PCN Title: Qualification of Additional Diodes Internal Assembly and Test Site

PCN-2663 REV 1

Qualification of Additional Diodes Internal Assembly & Test Site (SAT)

Table 2 – Part Marking Format

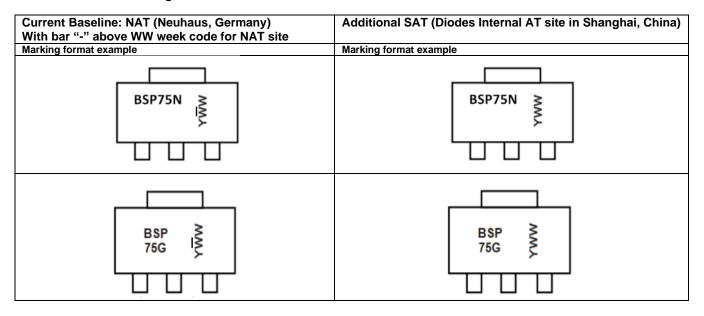
Table 2 – Part Marking Format
